**CAMINO REAL REGIONAL MOBILITY AUTHORITY
BOARD RESOLUTION**

THAT the Executive Director be authorized to execute Change Order No. 3 with Jordan Foster Construction, LLC., to address a conflict between a proposed curb inlet and an existing water line in the Eastlake Boulevard Phase 2 Project.

CCSJ:	<u>0924-06-500</u>
Project:	<u>Eastlake Phase II</u>
Highway:	<u>Eastlake Blvd.</u>
County:	<u>El Paso</u>
District:	<u>N/A</u>
Contract Number:	<u>N/A</u>

EASTLAKE BLVD.
PHASE 2
MODIFIED
INLET B-11

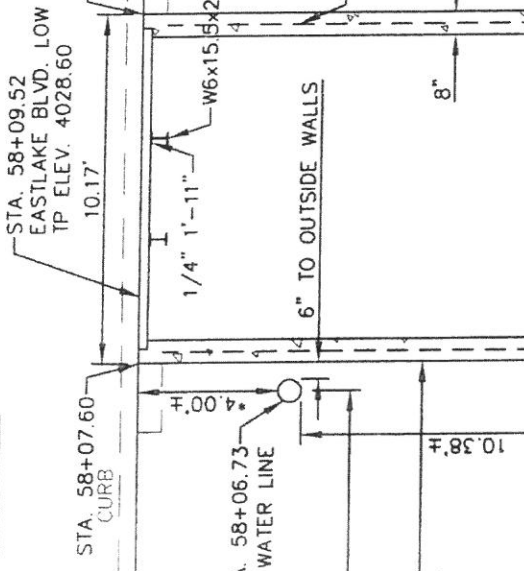
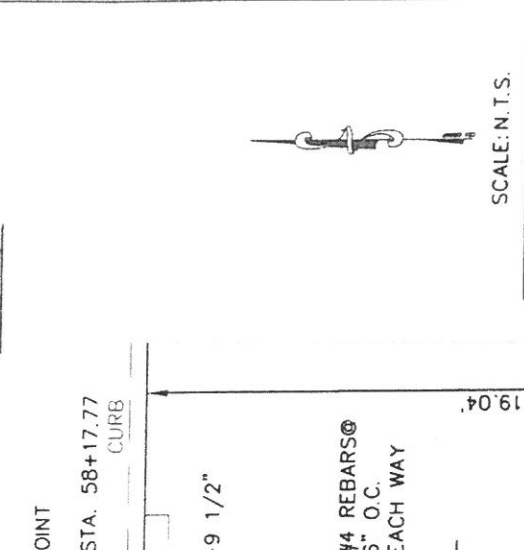
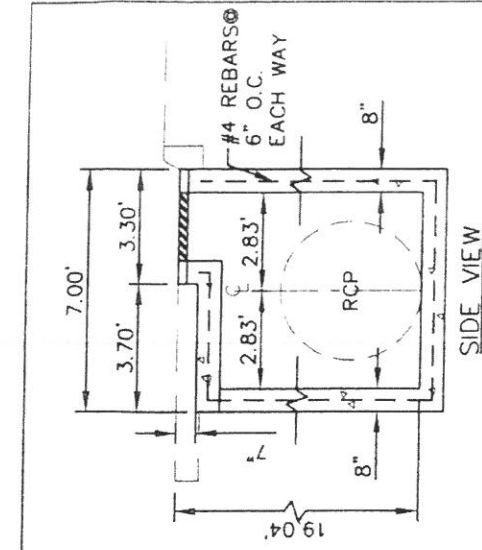
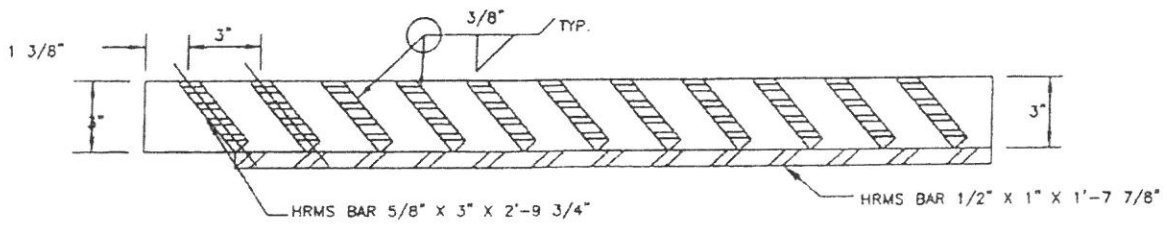
WHEREAS, a issue has been identified in which a proposed curb inlet would conflict with an existing water line and therefore the parties desire to change the proposed curb inlet to a surface grate inlet; and

This change order is to pay the contractor to modify curb inlet B-11 to a surface grate inlet due to a conflict with an existing water line. This change order will not affect pedestrian elements. No days are to be added by this CO for completing the work. Price for the item was determined to be fair and reasonable.

- SCALE: N.T.S.
- DATE: 4-3-17
- NOTES:
1. WATER AND SANITARY SEWER INFORMATION AS PER "EASTLAKE PHASE-2 WATER AND WASTEWATER IMPROVEMENT PLANS" BY TRE & ASSOCIATES DATED 12-9-16.
 2. TYPE II GRATE & FRAME AS PER HORIZON CITY DESIGN STANDARDS.
 3. PROVIDE CLASS "H" CONCRETE IN ACCORDANCE WITH ITEM 421 AND HAVING A MINIMUM COMPRESSIVE STRENGTH OF 5,000 PSI.
